1 Products affected

Product hierarchy no. *			Part no.	SBU	Type / Description	Customer part no.
SBU	PG	PUG	Type			
80	084	002	0000006516	See list below	800840020000006516	FMBB NEO

Product Change Notification					PCN FMBB NEO Redesign		
owner	creation date	release date	released by	change order no	rev	page	D10-021-376
segatro	10.01.2018	10.01.2018	romanogu	2014495	B	1 of 4

Old product appearance	New product appearance

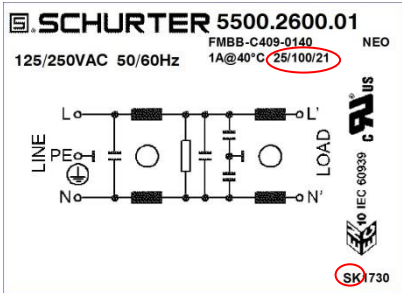
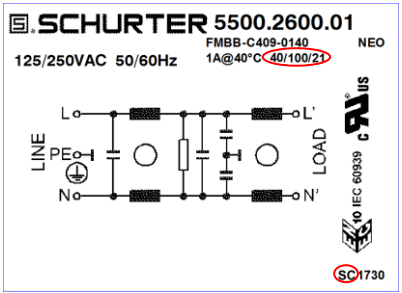
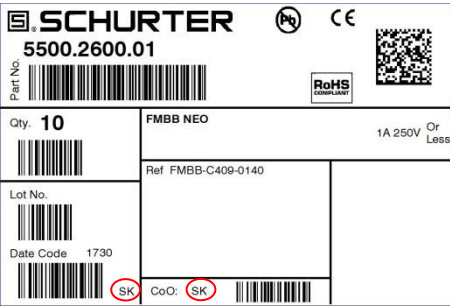
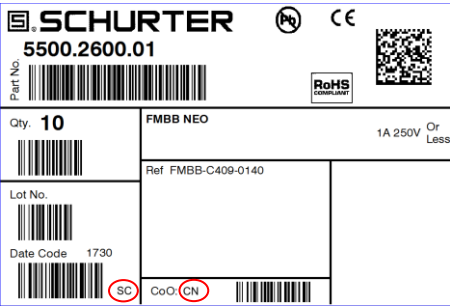
- Nickel plated case instead of aluminium case
- New cases are provided with a bottom cover
- Different shape of external quick connect terminals
- Production transfer from Slovakia (SK) to China (CN)
- Change of climatic category, from 25/100/21 to 40/100/21

- Change of product appearance due to new nickel plated case instead of aluminium case and different shape of quick connect terminals see photo below
- Change of factory code from SK to SC and origin from SK to CN on product and packaging labels, see below
- New climatic category indication on product label, see below
- Change of mechanical drawings, product appearance only, no dimensions, see below
